Pilot Region-Based Optimization Program for Fund-Lead Sites in EPA Region 3

Site Optimization Tracker: Hellertown Manufacturing Hellertown, Pennsylvania

Site Optimization Tracker:
Hellertown Manufacturing
Hellertown, Pennsylvania

Report of the Remediation System Evaluation,
Site Visit Conducted at the Hellertown Manufacturing Superfund Site
June 5, 2001

Capture Zone Width Calculation Results

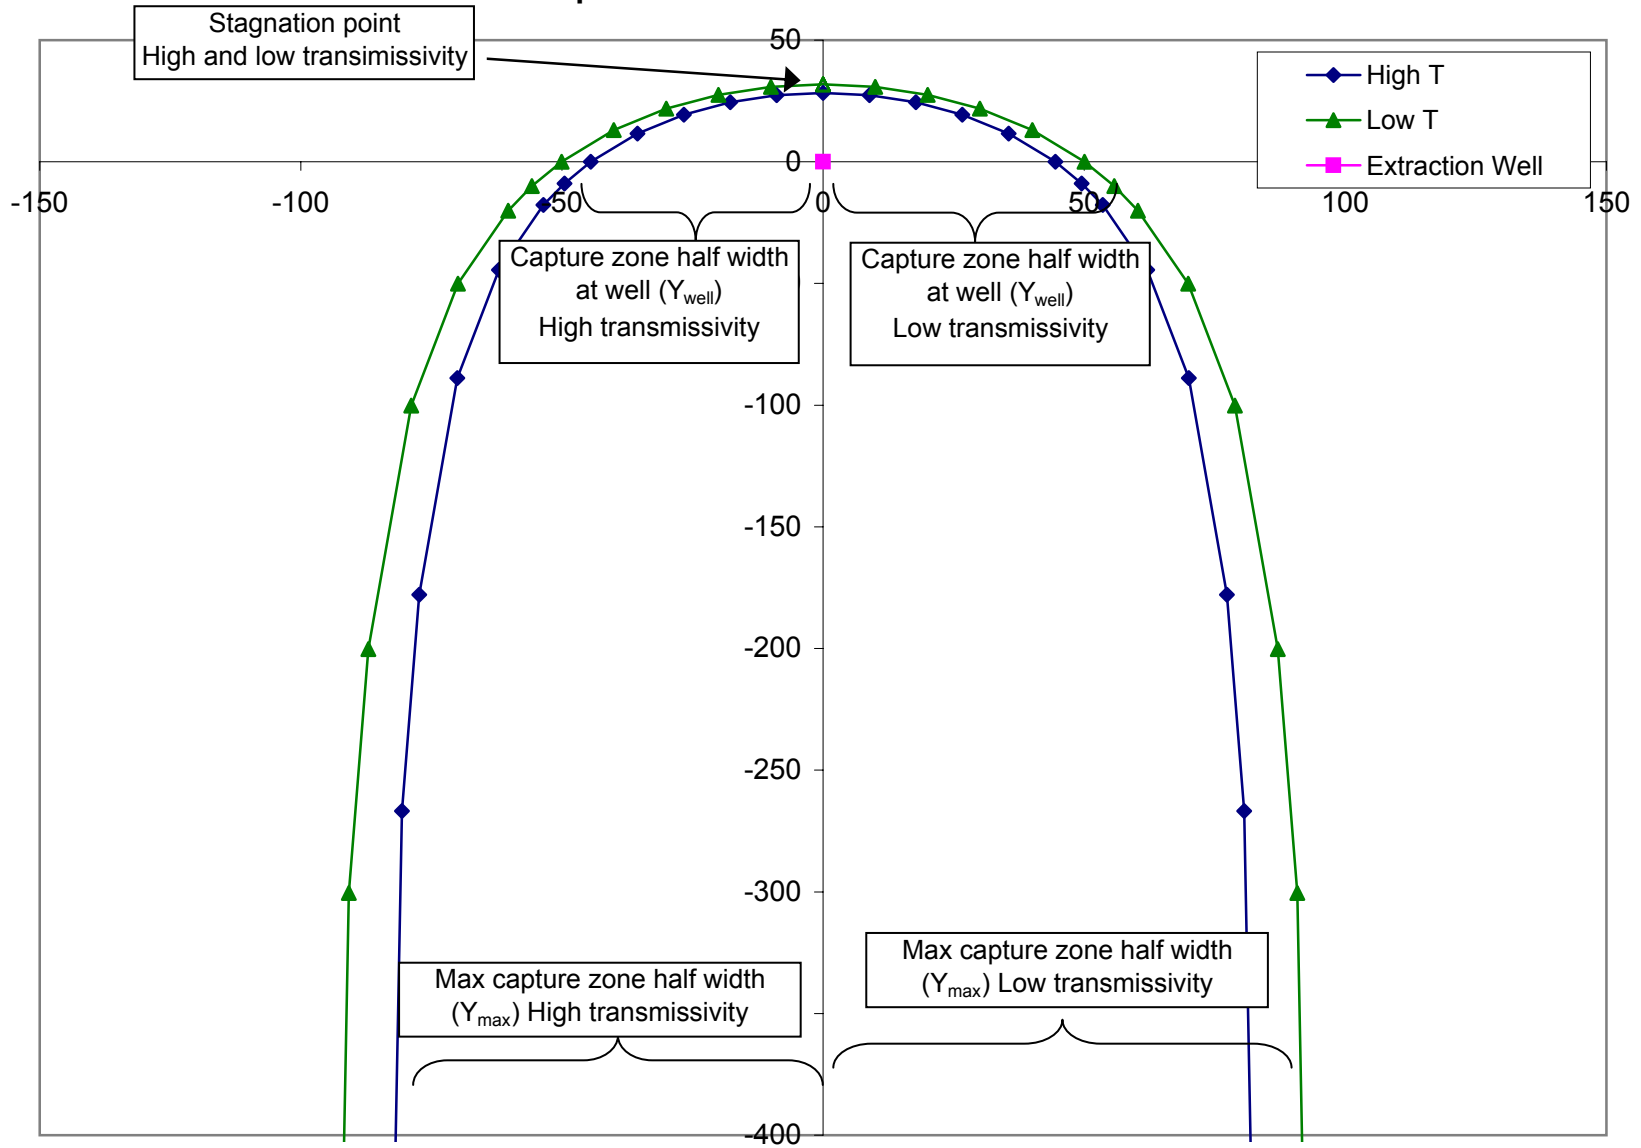
2. When installing the new wells downgradient of the extraction well, the wells should be placed beyond the stagnation point of the capture zone. The calculations in Appendix A suggest a range of likely locations for the stagnation point when pumping at 135 gpm, assuming the aquifer is 200 feet deep, there is a hydraulic gradient of 0.03 feet per foot, and the transmissivity ranges from approximately 4,300 to 4900 ft² per day (high and low estimates from site documents). The calculations suggest that the stagnation point is at 28 to 32 feet downgradient of the extraction well. The transmissivity could easily fall outside of the above-mentioned range. To be conservative, it is suggested that the site team place the proposed monitoring wells at least 100 feet downgradient of the extraction well. Based on site maps and discussions during the followup meeting on 12/16/04, the proposed locations indicated are much further downgradient and should be sufficiently conservative to avoid installing the new monitoring wells within the capture zone.

Calculation of the capture zone stagnation point

The spreadsheet and chart on the following pages calculates the estimated distance between the extraction well and the capture zone stagnation point.

Capture Zone Width Calculation Results (Low T)			
Input Parameters		Output Parameters	
Transmissivity T (ft ² /day)	4325	Stagnation Distance X ₀ (ft)	-31.88
Pumping Rate Q (gpm)	135	Max Capture Half Width Y _{max} (ft)	100.14
Pumping Rate Q (ft ³ /day)	25,900	Capture Half Width at Well Y _{well} (ft)	50.07
Hydraulic Gradient i (ft/ft)	0.03

Capture Zone Width Calculation Results (High T)			
Input Parameters		Output Parameters	
Transmissivity T (ft ² /day)	4871	Stagnation Distance X ₀ (ft)	-28.30
Pumping Rate Q (gpm)	135	Max Capture Half Width Y _{max} (ft)	88.92
Pumping Rate Q (ft ³ /day)	25,900	Capture Half Width at Well Y _{well} (ft)	44.46
Hydraulic Gradient i (ft/ft)	0.03

Information regarding replacement pumps for the extraction well

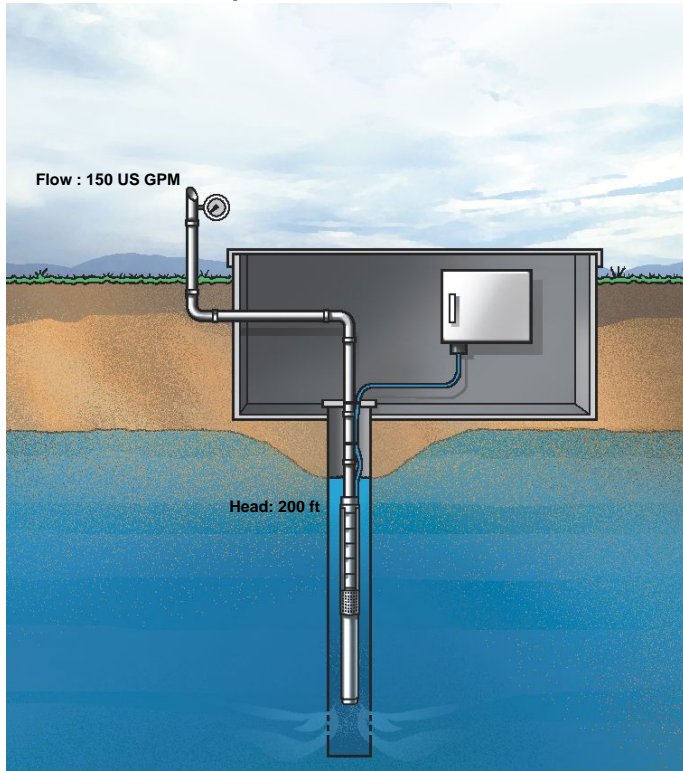
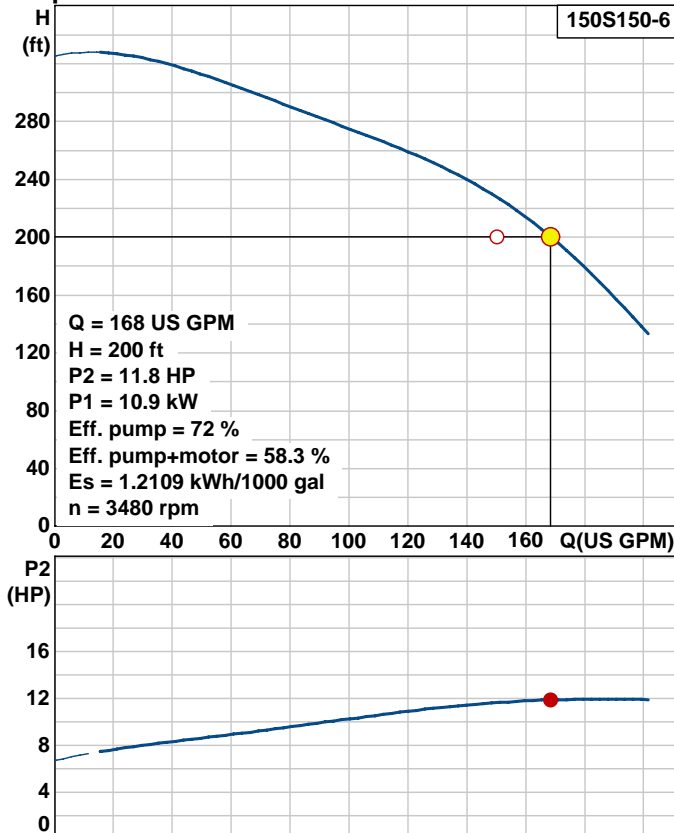
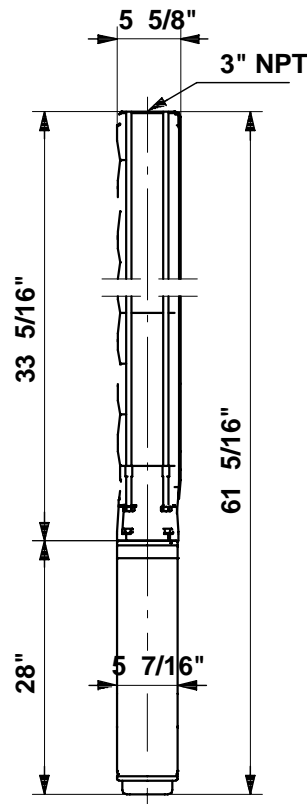
At the request of the RPM, information on a replacement pump is provided in Appendix A.

A contact from Pumps-On-Line (877-863-5360), provided a quote of \$2,800 (for pump and motor) delivered to the site via common carrier. Please note that the attached quote of \$4,320 is the Grundfos list price and that the \$2,800 reflects a discount offered by the vendor. Actual installation costs would be somewhat higher, but should be under \$10,000. A comparable Goulds pump (6DLC020 or 150L15 6 stage) was not available from the same vendor, but list prices quotes obtained directly from Goulds ranged from \$4,000 to \$4,700.

FIGURE 1-1. SITE LAYOUT SHOWING THE LOCATIONS OF THE MONITORING WELLS AND THE EXTRACTION WELL.

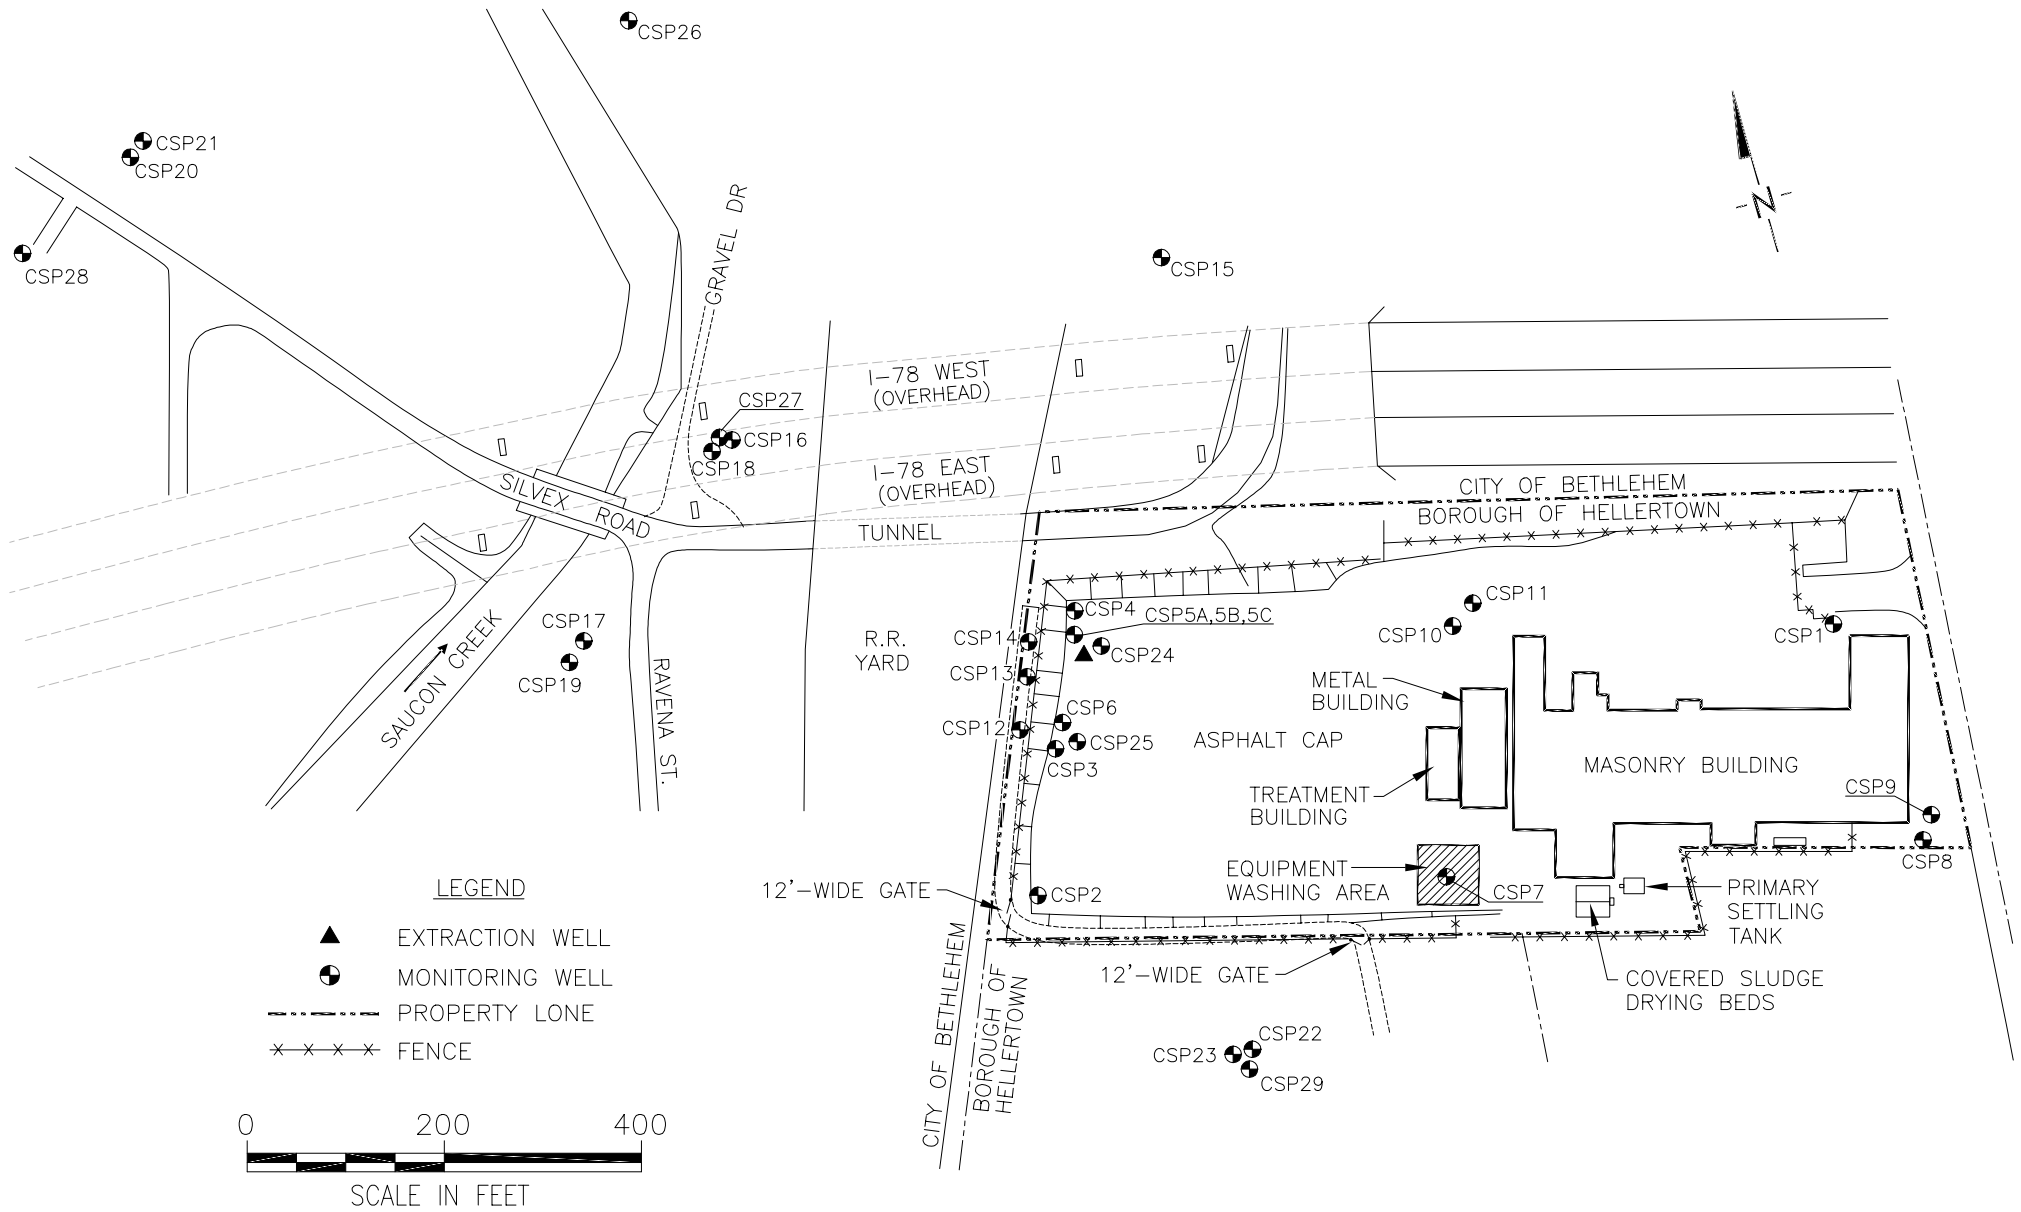
The November 2000 water levels provide sufficient information from the shallow bedrock wells to suggest that ground water in the shallow bedrock near wells CSP-12, CSP-13, CSP-14, and CSP-5A is captured by the extraction well. Data is too sparse to estimate ground water directions and capture in the overburden and the deep bedrock or in the shallow bedrock further from the extraction well. Because no monitoring wells or water-level measurements exist for over 400 feet to the west (downgradient) the extent of contamination and capture is unknown downgradient of CSP-12, CSP-13, CSP-14, and CSP-5A.

Ideally, one or more monitoring wells in the shallow bedrock should be added between CSP-14 and Saucon Creek, to allow increased resolution for water level evaluation as well as water quality evaluation. The ability to add one or more wells in that area may be hampered by access issues, as well as limitations due to steep slopes immediately west of CSP-14. To add one well should cost approximately \$20,000 in capital costs, and additional sampling and analysis of that well will be less than \$2,000 per year.
